ADDENDUM NO. 7
NEW CREAMERY ROAD SEWAGE PUMP STATION
CONTRACT NO. 001

Addendum 7, March 13, 2023.

TOWN OF EMMITSBURG, MARYLAND
NEW CREAMERY ROAD SEWAGE PUMP STATION

PRECAST CONCRETE BUILDING PLAN - GRADE LEVEL
SCALE: 3/8" = 1'-0"

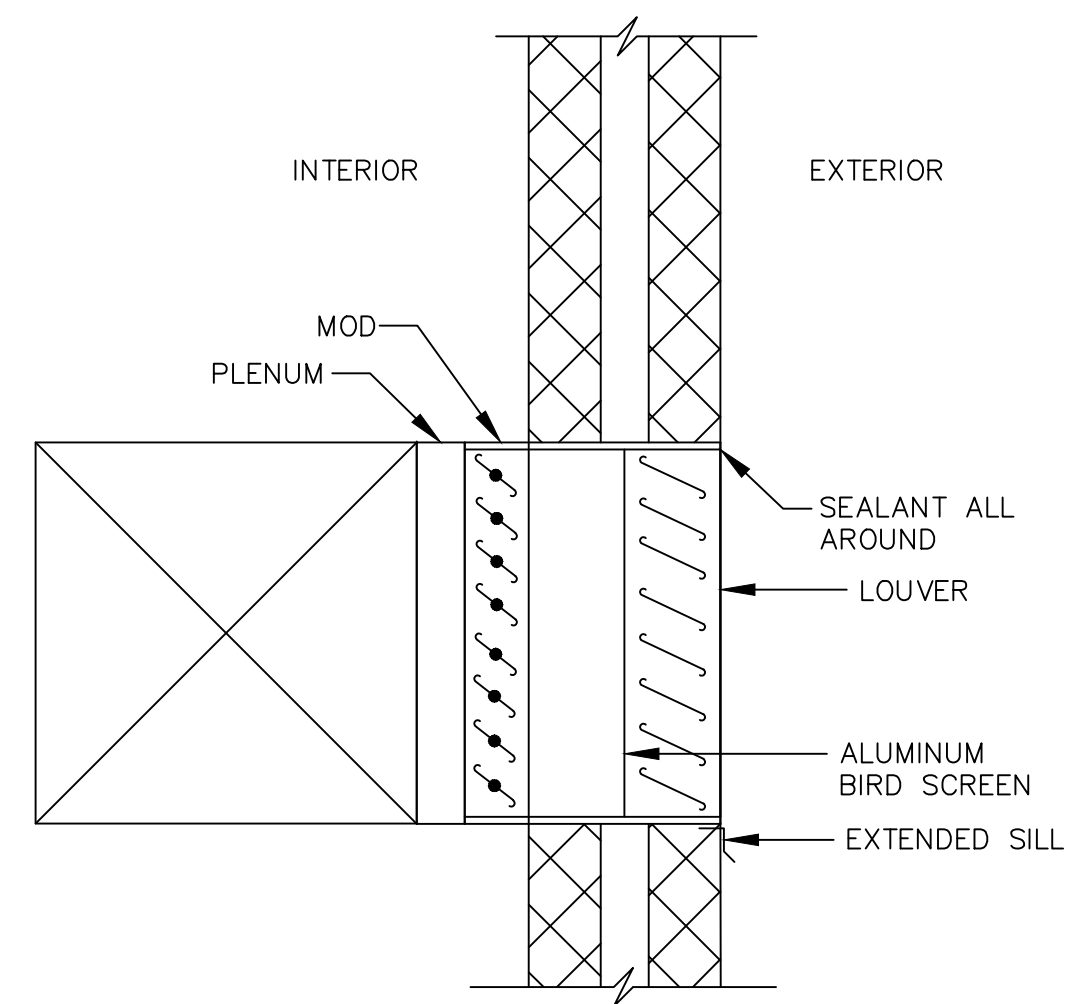
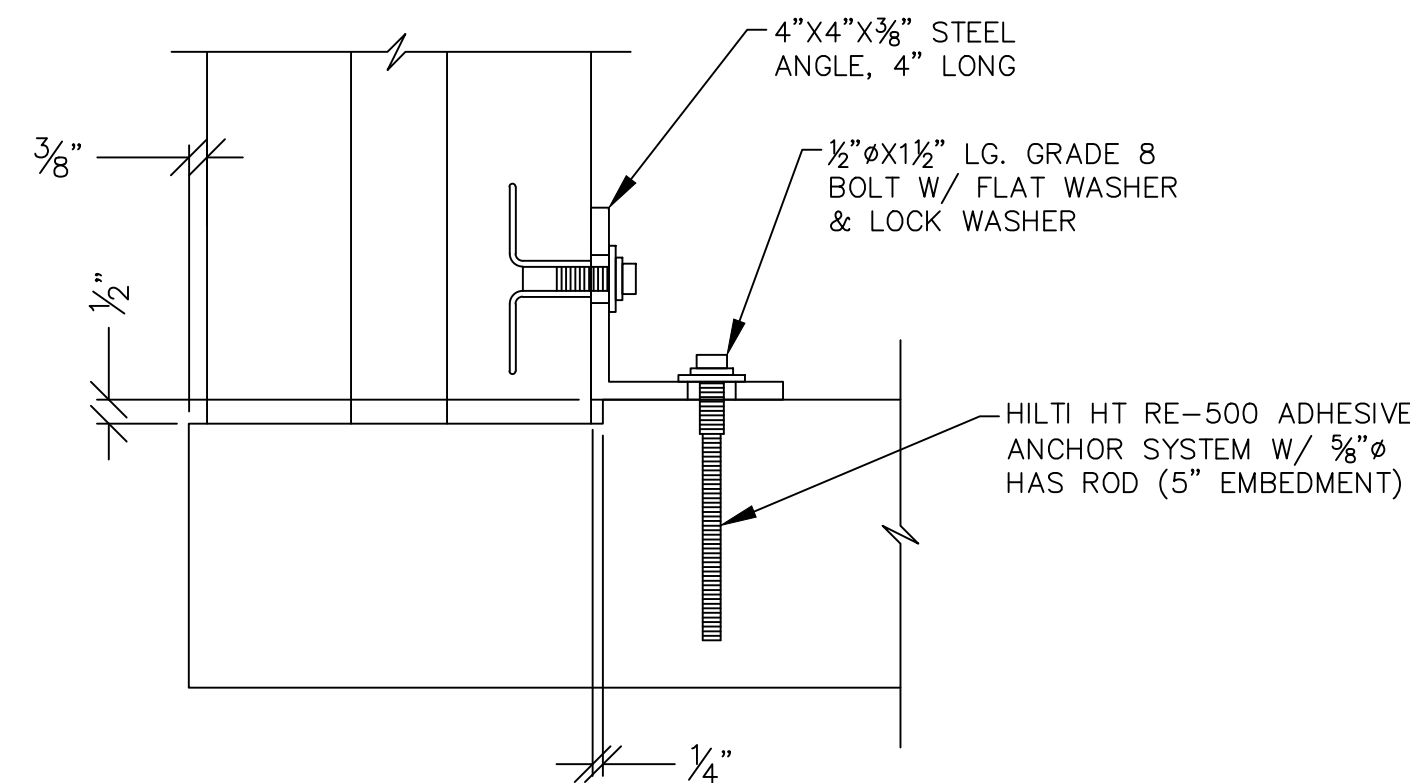
1. The precast concrete building dividing wall shall be MIN 4" and MAX 8" as shown on the attached Sheet S3.
2. The roof slab shall be as shown on the attached revised Sheet S4.
